## **Access Compliance Report Public Rights-of-Way** (Curb Ramps)

Intersection ID: 50595 Main Street: BENDING BRANCH RD Cross Street: GRAY\_WILLOW\_RD Location: ADA ID: F353D7875F34 Ramp Type: Perp Initial Pass/Fail: Fail **Overall Compliance: No** Severity Score: 21.25

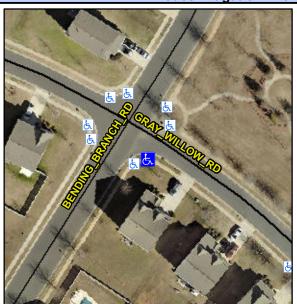
**GRAY WILLOW RD** Street 1 Name Stop Condition-Street 2 None Street 2 Name N/A Stop Condition-Street 1 N/A Possible Solutions: Remove & Replace Entire Ramp. Surveyor Notes: N/A PROW/ADA: Not Found, R304.5.1, R304.2.2

Field Measurements/Component Compliance					
Compliance Description		Data	Comp	liance Description	Data
N/A	Ramp Length (in)	48.0	No	Ramp Slope (%)	11.2
No	Ramp Width (in)	47.5	Yes	Ramp XSlope (%)	1.4
N/A	Flare Type LT	N/A	N/A	Flare Type RT	N/A
N/A	Flare Slope LT (%)	N/A	N/A	Flare Slope RT (%)	N/A
N/A	Flare Traversable LT?	N/A	N/A	Flare Traversable RT?	N/A
N/A	Landing Length (in)	N/A	N/A	DWS Provided?	N/A
N/A	Landing Width (in)	N/A	N/A	DWS Contrast?	N/A
N/A	Landing Slope (%)	N/A	N/A	DWS Length (in)	N/A
N/A	Landing X Slope (%)	N/A	N/A	DWS Full Width?	N/A
N/A	Landing Curb? (Y/N)	N/A	N/A	DWS Offset (in)	N/A
N/A	Shared Landing?	N/A			
N/A	Gutter Ponding?	N/A	N/A	Gutter Slope (%)	N/A
N/A	Gutter Lip Ht (in)	N/A	N/A	Gutter X Slope (%)	N/A
N/A	Painted X Walk1?	No	N/A	Painted X Walk2?	N/A
	X Walk 1 Direction	To NE		X Walk 2 Direction	N/A
N/A	X Walk 1 Width (in)	N/A	N/A	X Walk 2 Width (in)	N/A
	X Walk 1 Slope (%)	0.8		X Walk 2 Slope (%)	N/A
